APPLICATION NO.	FILING DATE	FIRST NAMED INVENTOR	ATTORNEY DOCKET NO.	CONFIRMATION NO	
09/901,307	07/09/2001	Kaoru Kagami	10110-5	7761	
75	90 08/21/2003				
Vincent O. Wagner Woodard, Emhardt, Naughton, Moriarty and McNett Bank One Center/Tower 111 Monument Circle, Suite 3700			EXAMINER		
			LE, THANH TAM T		
Indianapolis, IN	,		ART UNIT PAPER NUMBER		
•			2839

A					
	Application No.	Applicant(s)				
Office Action Summer	09/901,307	KAGAMI ET AL.				
Office Action Summary	Examiner	Art Unit				
	Thanh-Tam T. Le	2839				
The MAILING DATE of this communication app Period for Reply	ears on the cover sheet with the d	correspondence address				
A SHORTENED STATUTORY PERIOD FOR REPL' THE MAILING DATE OF THIS COMMUNICATION.  - Extensions of time may be available under the provisions of 37 CFR 1.1: after SIX (6) MONTHS from the mailing date of this communication.  - If the period for reply specified above is less than thirty (30) days, a reply If NO period for reply is specified above, the maximum statutory period of Failure to reply within the set or extended period for reply will, by statute  - Any reply received by the Office later than three months after the mailing earned patent term a

Fig. 5

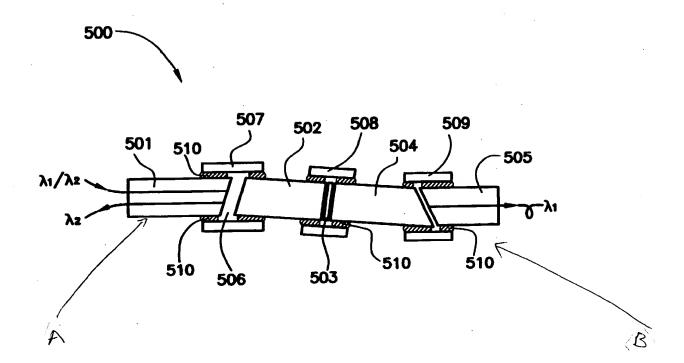
Regarding claims 1, 6 and 14-16, Zhu et al., figure 5, disclose an optical signal separating device comprising a plurality of optical multi/demultiplexers (abstract), each of the optical multi/demultiplexers (500, fiber-optic apparatus) comprising:

- an wavelength selection filter (503) for selectively transmitting light of a
   certain wavelength range and reflecting light of other wavelength ranges;
- a first optical system (A, attachment) having an optical fiber (not shown) for guiding light to be transferred to the wavelength selection filter from the wavelength selection filter;

- a second optical system (B, attachment) having an optical fiber (not shown)
   for guiding light transferred from the wavelength selection filter. The second optical system being opposingly arranged to the first optical system while interposing the wavelength selection filter therebetween; and
- outer cylindrically shaped glass holders (507, 508 and 509, column 5, lines 5 6) for holding the optical first optical system, the optical and the second optical system secured thereto, respectively.

Regarding claims 2, 7 and 17, figure 5, each of the first and second optical systems comprising a lens (502, 504) optically connecting the wavelength selection fiber and the optical filter respectively. The wavelength selection filter being secured to one of the lenses of the first and second optical systems.

Regarding claims 3, 8 and 18, figure 5, each of the first and second optical systems comprising an optical fiber holder (501, 505) which having a through hole (not shown) for receiving the optical fiber inserted therein.
